# ADDENDUM 05

| PROJECT: | Exeter Twp ESC | MWS PROJECT NO: | 25-049 |
| ADDRESS: | 70 Gibraltar Road | | |

## 1 ADA SIGNAGE MOUNTING LOCATIONS

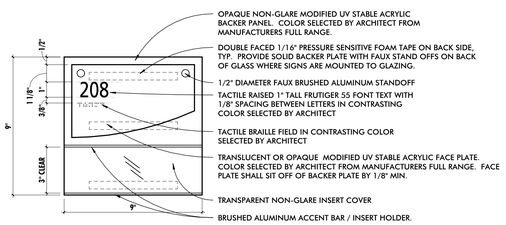
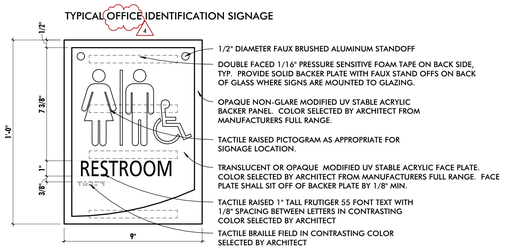
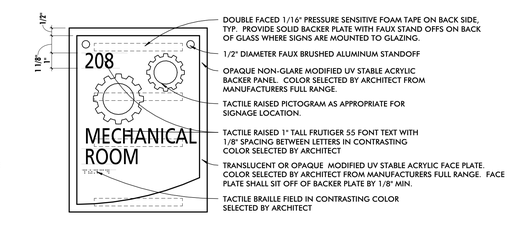
1.) G000: Included for reference.
2.) G005: Clarified room signage types.
3.) LP-1: Removed phasing verbiage.
4.) SPE-1: Adjusted scoping verbiage.
5.) A106: Clarified scope for many equipment items. Removed three screens.

SPECIAL EXCAVATION MATERIAL DETAIL 'A'

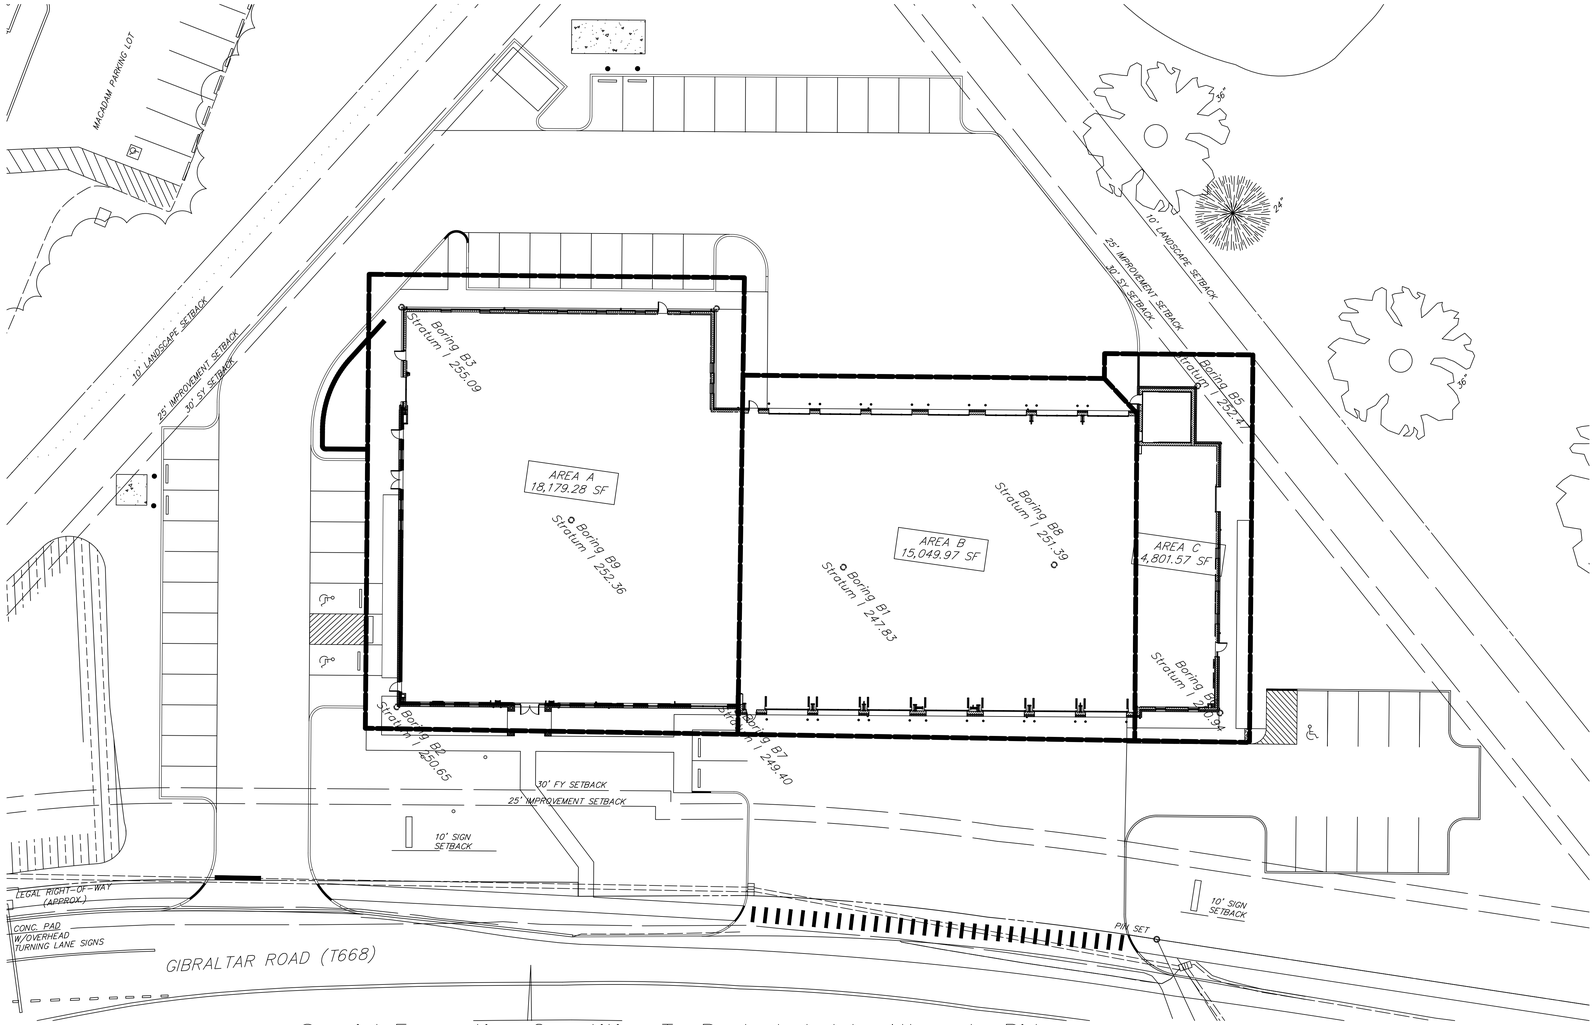
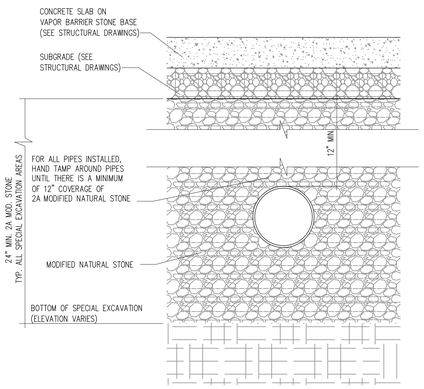
134.) QUESTION: Notes #1 and #3 on drawing SPE-1 issued in addendum #2 appear to assign the over excavation work to both the site and general contractor. Please confirm the site contractor is responsible to complete the building pad to subgrade if the alternate is accepted.

RESPONSE: The Site Contractor is responsible to complete the building pad to subgrade in any case. Note #1 on drawing SPE-1 has been updated and provided with this Addendum.

## 1 EQUIPMENT PLAN
1/8" = 1'-0"

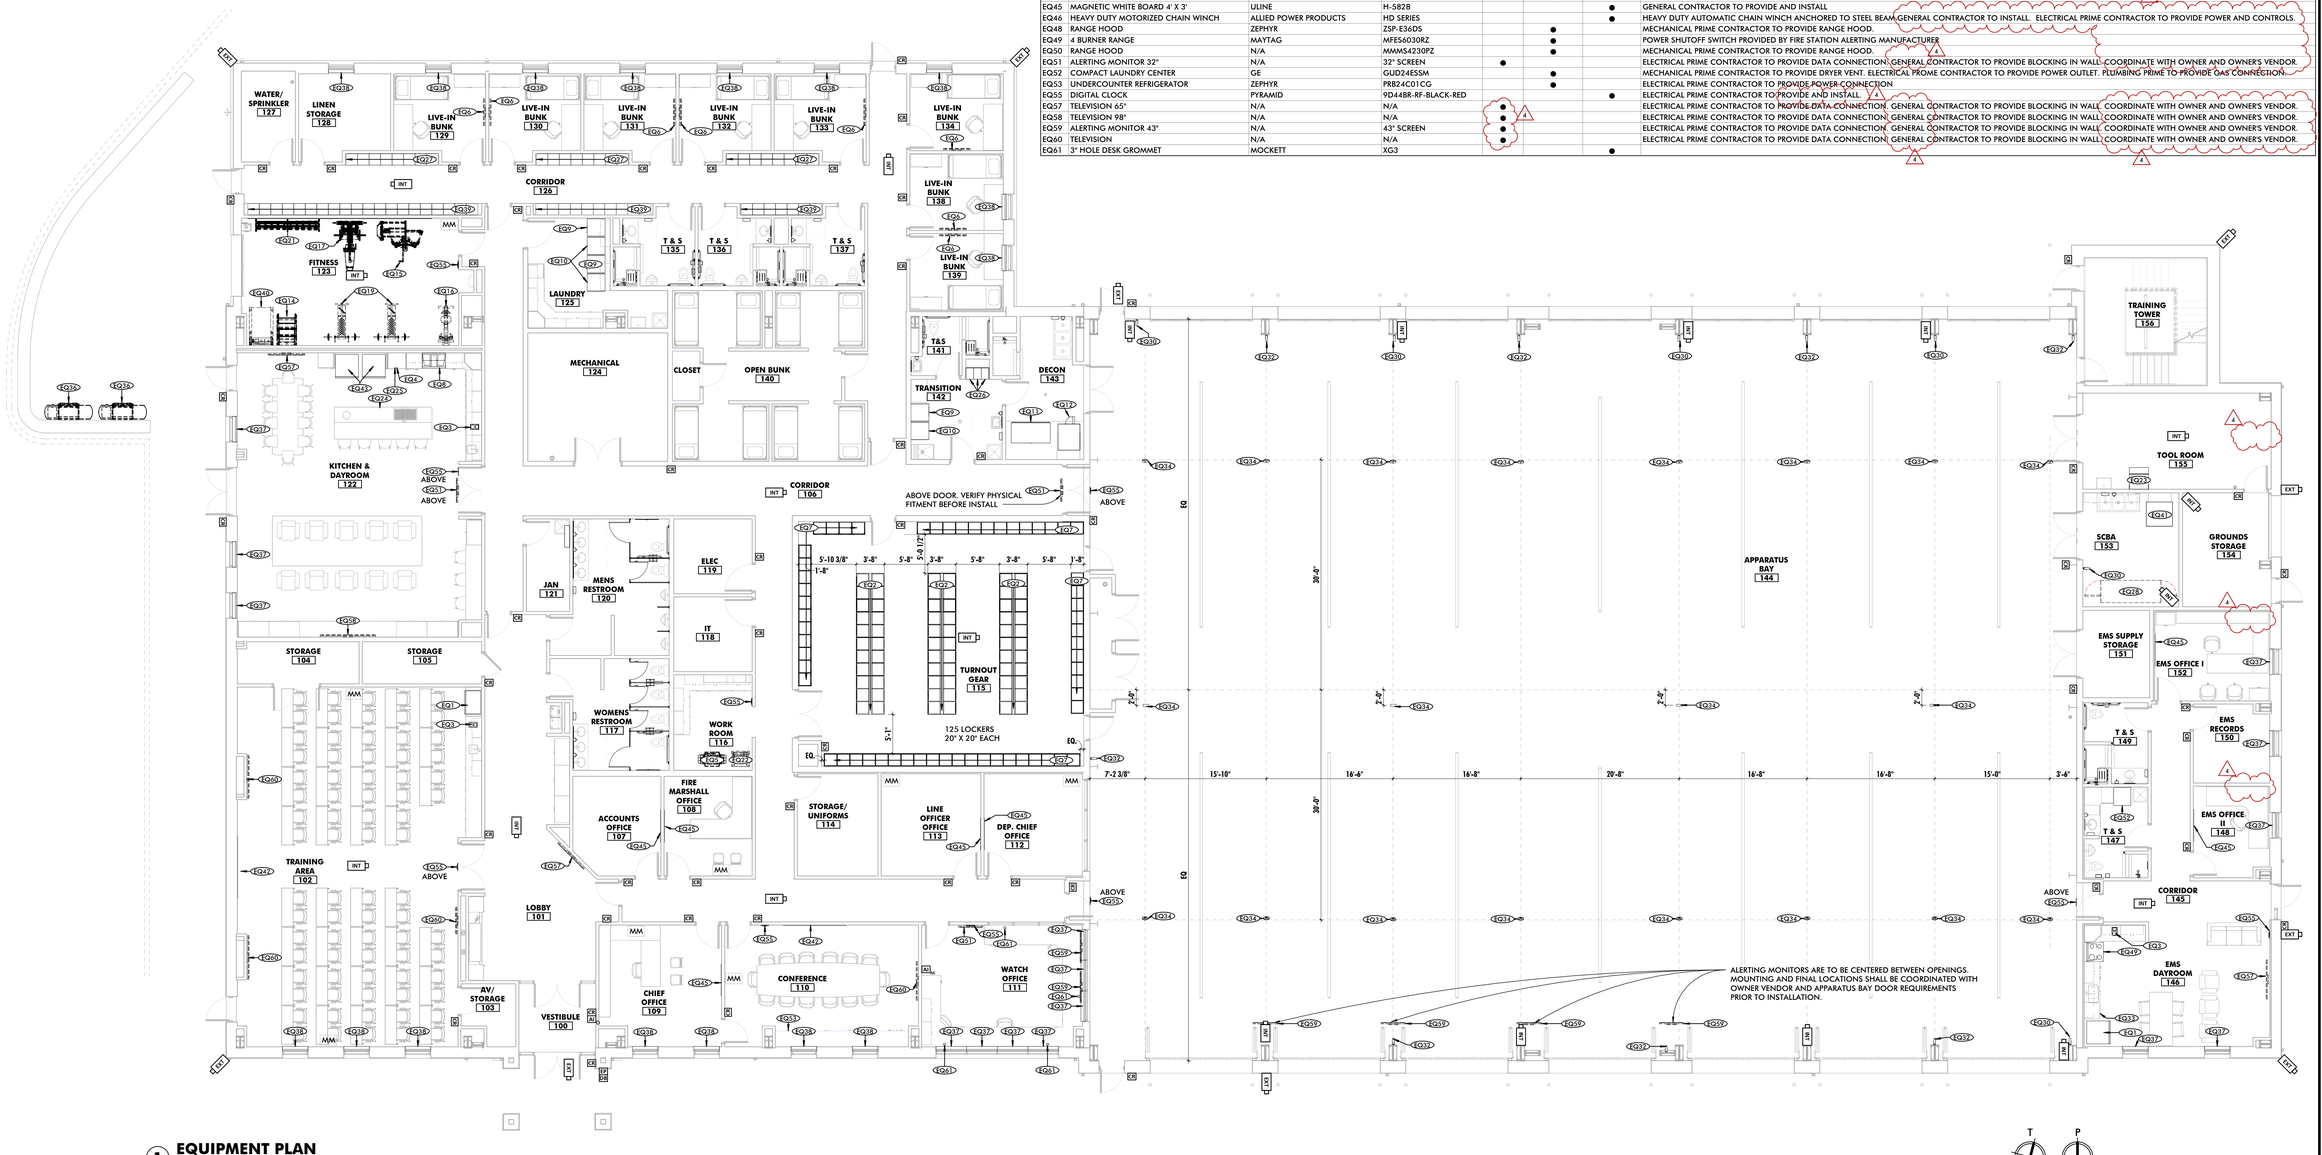
150.) QUESTION: (Div 11) - Sheet A106 (rev. Add 02) shows EQ30 air hose port as contractor furnished and installed but does not name the contract. Which prime contract (GC, PC, HVAC or EC) furnishes, installs and connects EQ30? Reference: A106 (rev. Add 02); Spec 01 1200, 1.15

RESPONSE: The PC will install EQ30. See revised A106 attached.

## 1 SOUTH ELEVATION
1/8" = 1'-0"

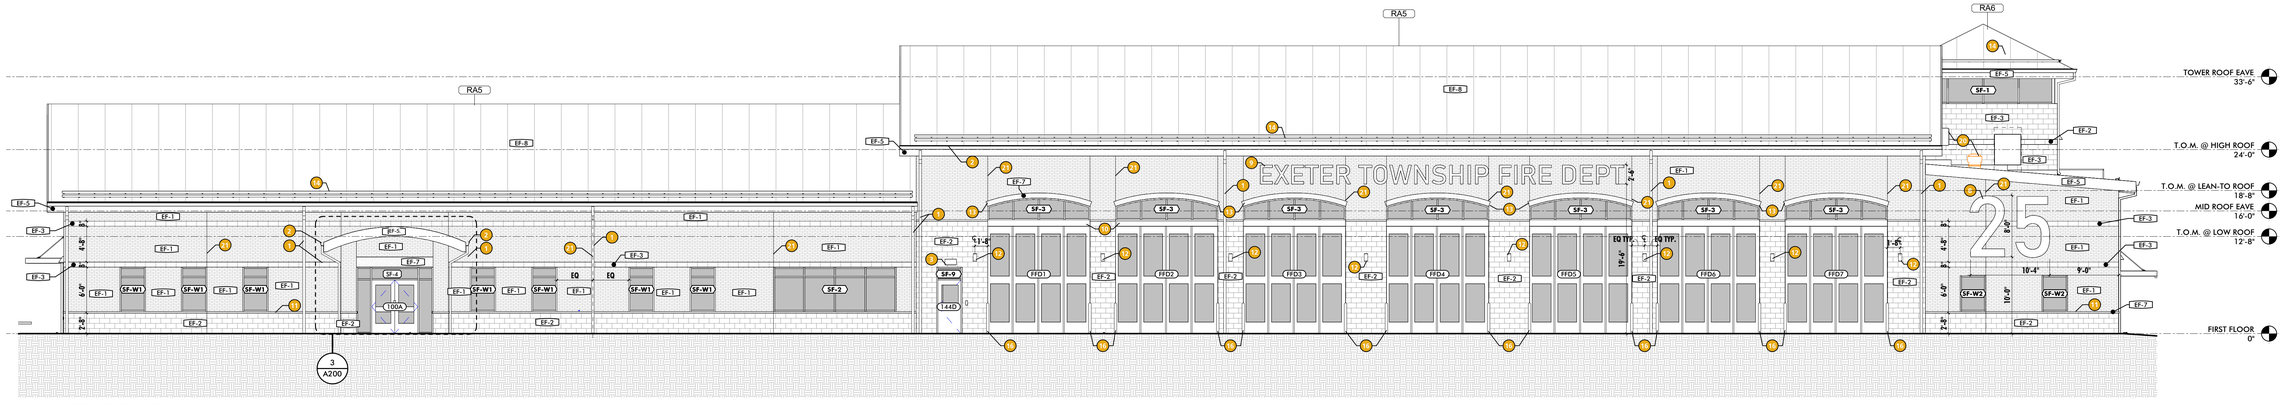
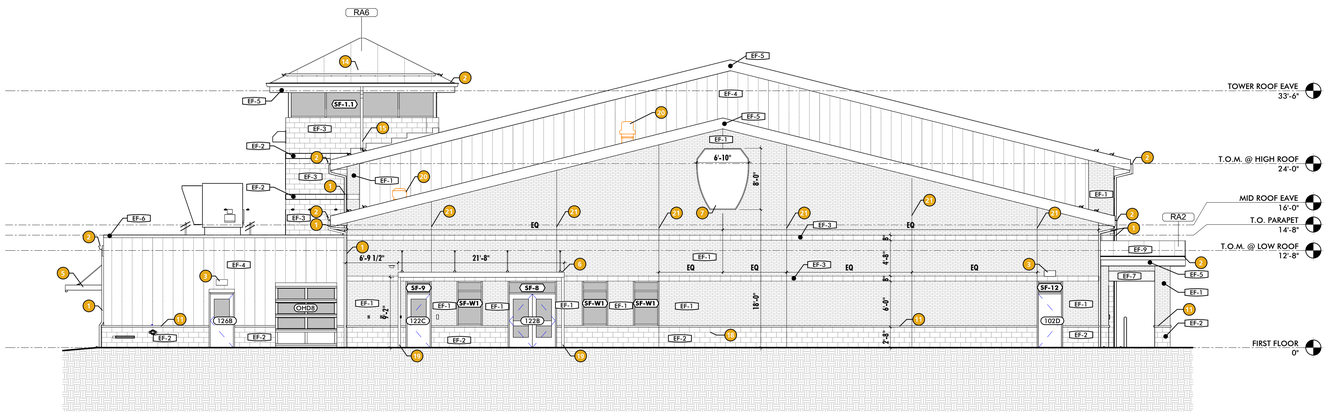
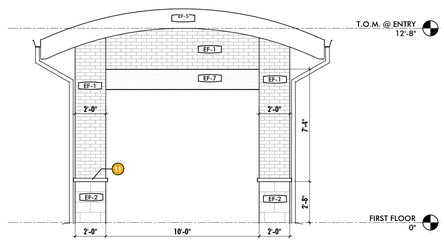
6.) A200, A201: Changed exterior railing thickness to match interior railings. Keynote 17 updated to match G001 scope. Added BOD model to EF-9.
7.) A404, A405: Revised masonry weep spacing.

# A604

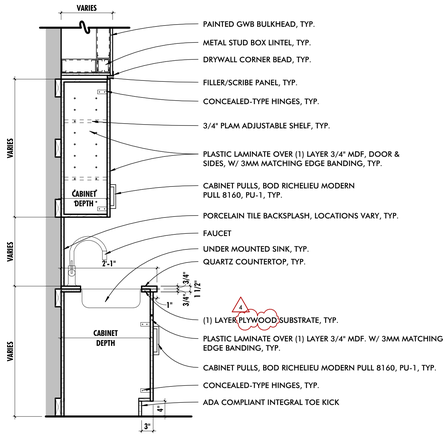
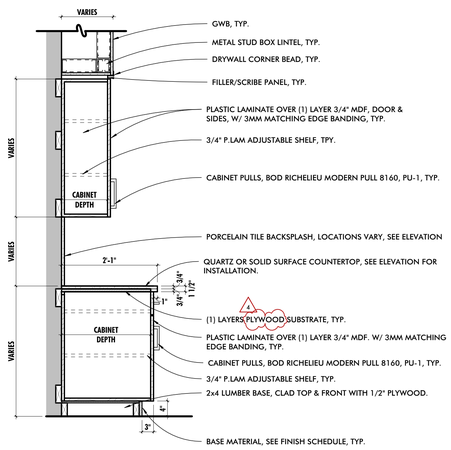
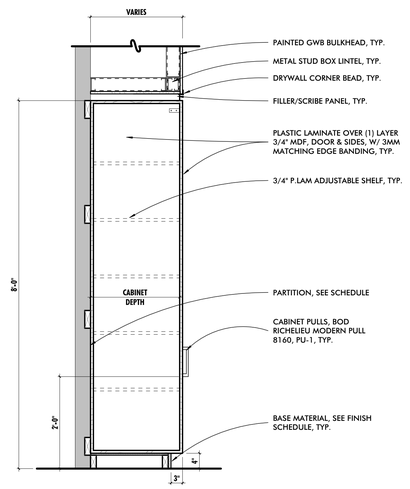
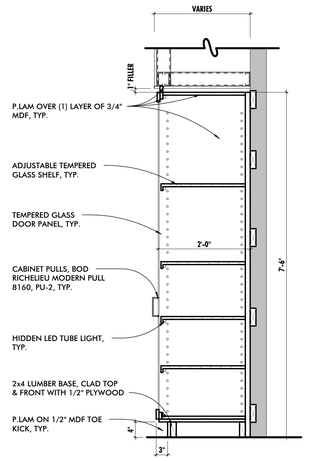
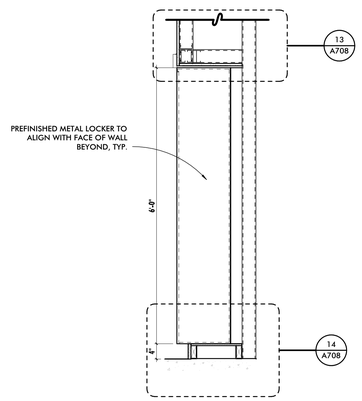
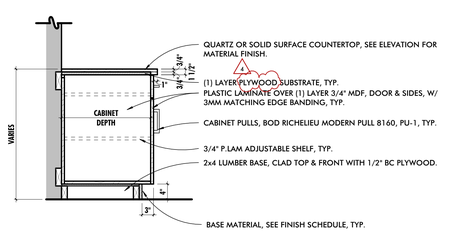
8.) A406: EQ46 is now tagged.
9.) A600: Doors 156C, 156D, and 156E are painted, not prefinished.
10.) A601: Clarified overhead door alternates.
11.) A604: Added typical shade mounting detail.

136.) QUESTION: If shades are not by owner: The window shade specification does not note the requirement of a fascia (top treatment) Please advise if it is required.

RESPONSE: A fascia will be required, see revised spec section 12 2400 attached. See revised detail SF-H1/A604.
